ECN/PCN No.: 4099

For Manufacturer			
<b>Product Description:</b> Oven Controlled Crystal Oscillator	<b>Abracon Part Number / Part Series:</b> AOCJY	<input type="checkbox"/> Documentation only <input checked="" type="checkbox"/> ECN <input type="checkbox"/> EOL	<input checked="" type="checkbox"/> Series <input type="checkbox"/> Part Number
<b>Affected Revision:</b> F	<b>New Revision:</b> G	<b>Application:</b>	<input type="checkbox"/> Safety <input checked="" type="checkbox"/> Non-Safety

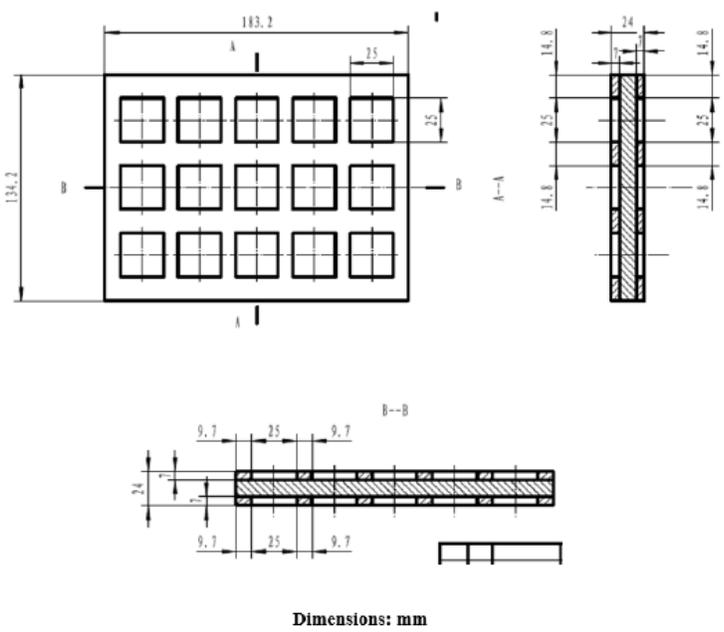
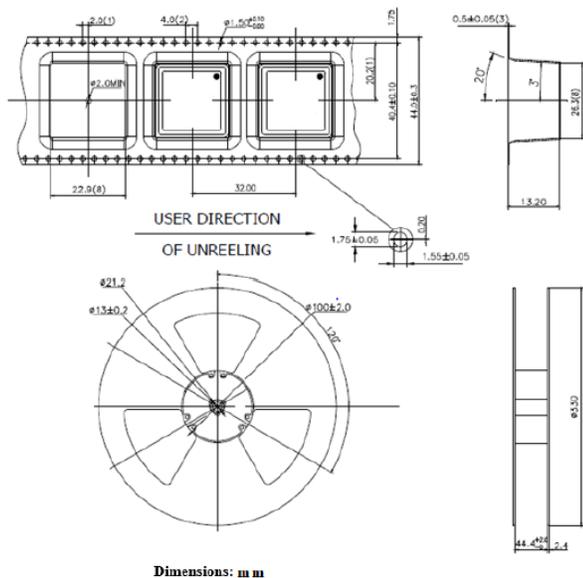
**After Change:**

**Packaging**

Tape & Reel=50 units  
 Tape & Reel packaging applies to MOQ>30 units

(15) units per tray  
 Tray packaging applies to MOQ less than or equal to 30 units
